## PARTS & SERVICE NEWS

REF NO.	AA04185
DATE	January 3, 2005

**SUBJECT:** AUTOMATIC TRANSMISSION CONTROLLER (ATC)

**PURPOSE:** To announce a special feature of the automatic transmission controller.

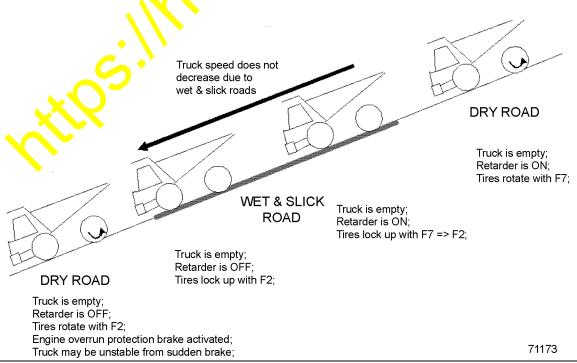
Some trucks may experience engine overrun while traveling down a slippery hauf road. Engine overrun is caused by a rapid downshift to the lowest transmission gear range (F. 171) during rear tire lock-up. This would most likely occur when an empty truck is traveling down a recently watered haul road. Refer to Figure 1 below.

When the rear tires recover traction, the ATC will attempt to shirt up to the appropriate gear. If shift up speed is not quick enough when compared to actual rear tire rotating speed, then the engine speed will increase and may initiate overrun protection. This activity results in the activation of the engine overrun protection brake. The truck may then become unstable.

In order to stabilize the truck in this situation the ArC downshift inhibit time has been set to prevent the transmission from downshifting to a lower gear. While downshifting, the transmission will hold the previous gear. The exact time of the downshifting will vary depending on the deceleration speed of the rear tires. To add this feature replace the standard ATC control with ATC control 7818-95-9000.
